Joint Comments of Environmental and Public Health Organizations on the Regulatory Impact Analysis Accompanying EPA’s Proposed Emission Guidelines for Greenhouse Gas Emissions From Existing Electric Utility Generating Units; Revisions to Emission Guideline Implementing Regulations; Revisions to New Source Review Program

**Docket No.
EPA-HQ-OAR-2017-0355**

October 31, 2018

Figure 1. System Costs Compared to CPP w/ EE, for all EPA runs from 2020-2035

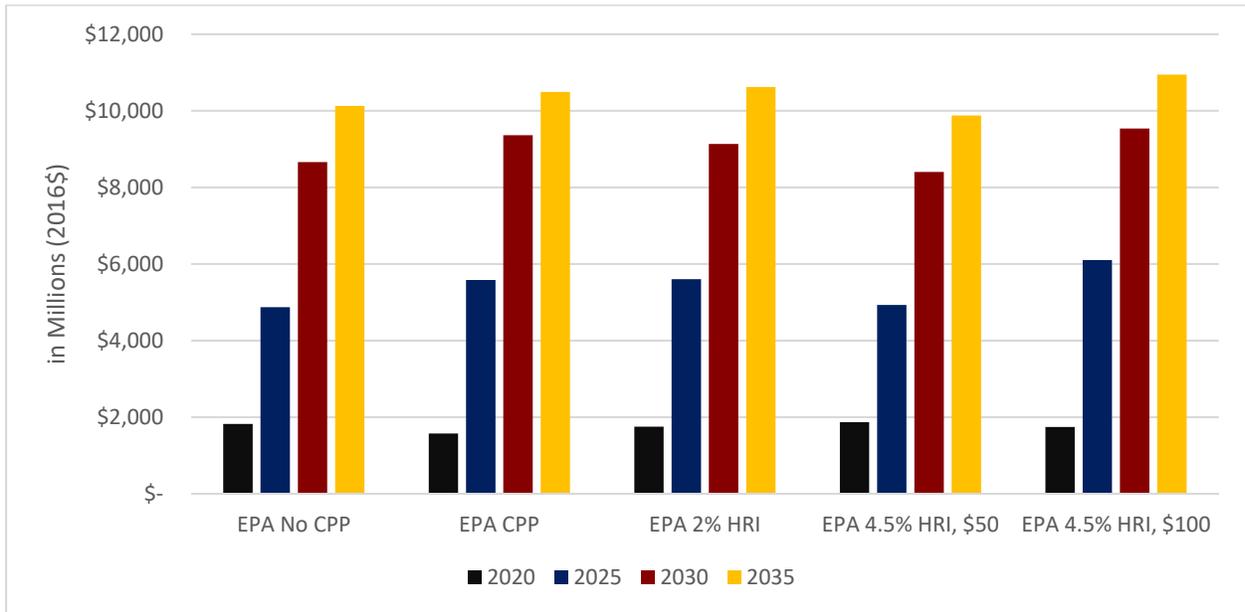
EPA did conduct a more realistic CPP base case that included incremental energy efficiency growth assumptions, but it did not use the "CPP-plus-EE" case for comparison with the proposed ACE policy scenarios. The ACE RIA shows that the power sector costs for the CPP-plus-EE case are less than for the CPP case without energy efficiency. The CPP-plus-EE case also resulted in lower emissions than any of the other CPP or ACE cases (see Figure 1). The CPP-plus-EE case also resulted in lower emissions than any of the other CPP or ACE rule cases (see Figure 2). By comparing the impacts of the proposed ACE rule to the CPP without energy efficiency instead of the more realistic CPP-plus-EE case, the ACE RIA artificially inflates the costs of the CPP and reduces the benefits foregone under the ACE rule. Moreover, EPA provided no justification for excluding energy efficiency from its modeled scenarios. EPA acknowledged the role of energy efficiency in the electricity system—and rightfully included energy efficiency in one scenario—but still arbitrarily and unreasonably excluded energy efficiency from the analysis that it used to justify the proposed rule.

Figure 3. Comparison of natural gas price projections

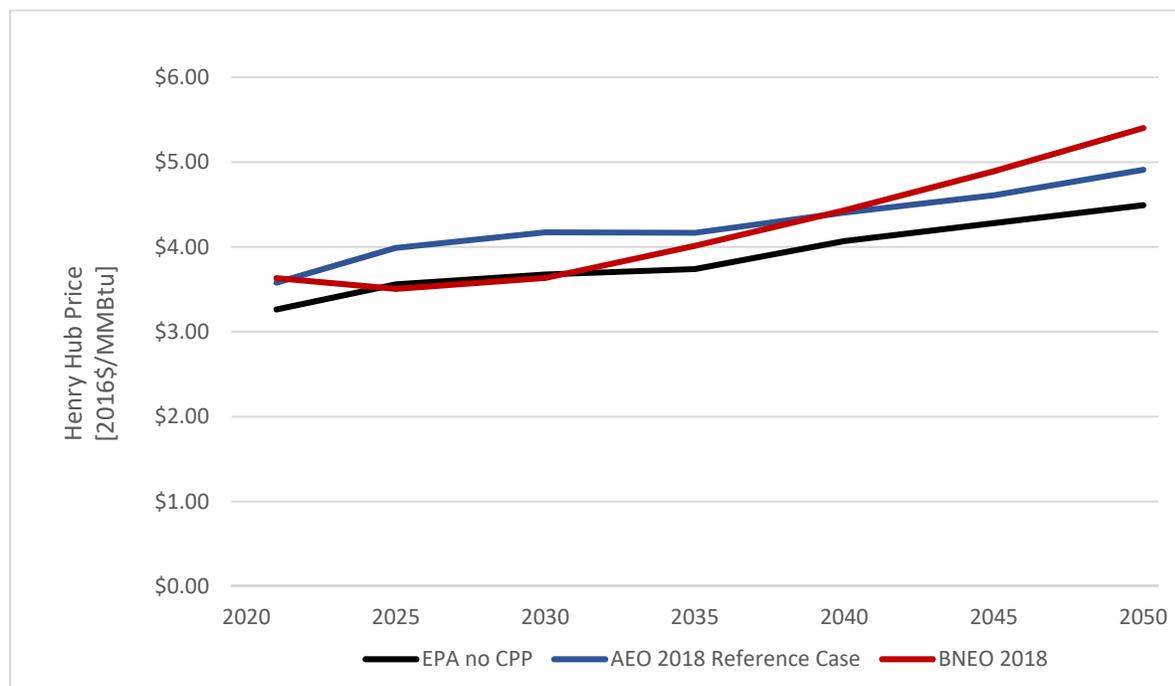
EPA's analysis should have bounded its projections of the CPP and ACE rules with a higher, though still realistic, gas price sensitivity consistent with market fundamentals analysis, such as the price projections given in the U.S. EIA Annual Energy Outlook (AEO) Reference Case.²⁶ Figure 3 shows a comparison between gas prices from EPA's no CPP scenario, EIA's AEO 2018 reference case, and Bloomberg New Energy Outlook (BNEO) 2018.²⁷ Averaged across the reported years, AEO 2018 and BNEO 2018 gas prices are about 11 percent and 8 percent higher, respectively, than EPA's prices. Though BNEO's forecast is in line with EPA's in 2025 and 2030, the significant divergence in the later years would influence decisions to retire coal and build new gas plants in the early years.

The ACE RIA's reliance on just one low gas price forecast leads to substantially less coal generation and lower total CO₂ emissions (as well as co-pollutants, like sulfur dioxide (SO₂) and nitrogen oxides (NO_x)) than would occur assuming AEO 2018 gas prices.

Figure 4. Projected coal and NGCC generation under different natural gas prices

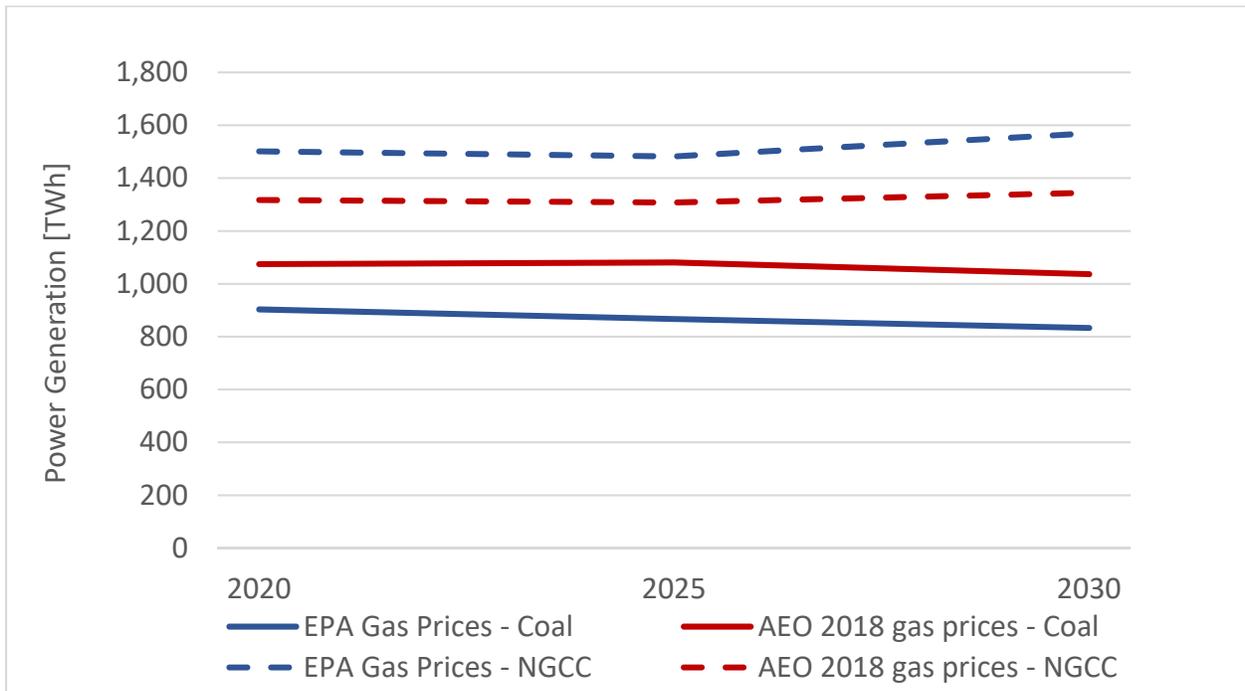
NRDC used IPM to model the impacts of the ACE RIA’s low gas price assumptions on the reference case results. Figure 4 shows the modeled electricity generation from coal and natural gas combined cycle (NGCC) power plants. The scenario with AEO 2018 gas prices results in 24 percent more generation from coal power plants in 2030 than the scenario with EPA gas prices. Figure 5 and Figure 6 show coal retirements and new NGCC capacity, respectively, under the two scenarios. Under AEO 2018 prices, fewer coal plants retire and fewer NGCC plants are built. Figure 7 shows total CO₂ emissions; AEO 2018 gas prices result in an estimated 50 million more tons of CO₂ emissions in 2030.

Figure 7: Projected CO₂ emissions under different natural gas prices

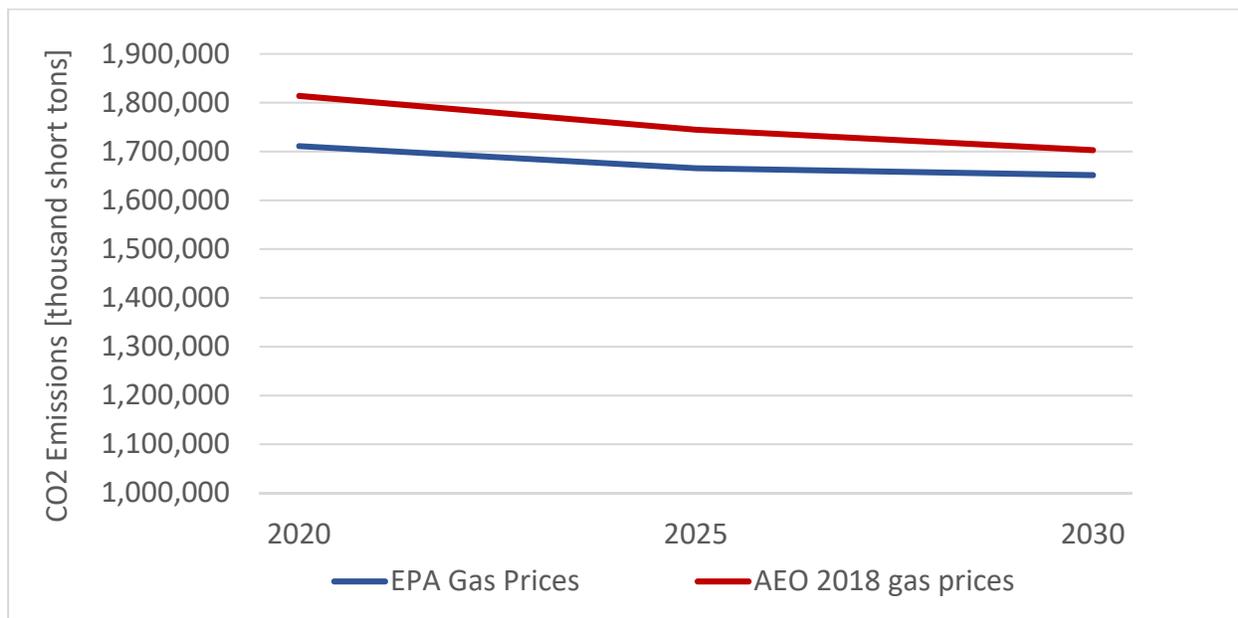
The impact of the low gas price assumptions on the policy scenarios is likely similar to the impact of those assumptions on the reference cases. The lower gas price assumptions lead to lower levels of generation from coal and therefore lower emissions. EPA’s lower gas price assumptions dampen the undesired impacts of the ACE rule—including a potential rebound effect—by suppressing coal generation. At the same time, EIA’s most recent modeling for its Annual Energy Outlook shows that the CPP would continue to deliver significant emission reductions even if gas prices are higher than forecast.²⁸ Under higher gas price assumptions that are more in line with other publicly available forecasts, therefore, EPA would likely have found that the ACE rule results in substantially higher emissions from the power sector than the CPP. Modeling a credible, higher gas price sensitivity that is more in line with EIA’s reference case projections would provide an informative and important range of values for all emissions—including CO₂, SO₂, NO_x, fine particulate matter (PM_{2.5}), and ground level ozone. The failure to consider these more-realistic outcomes represents a failure to consider an important aspect of the problem and renders EPA’s analysis invalid and its proposed ACE rule arbitrary and capricious.²⁹
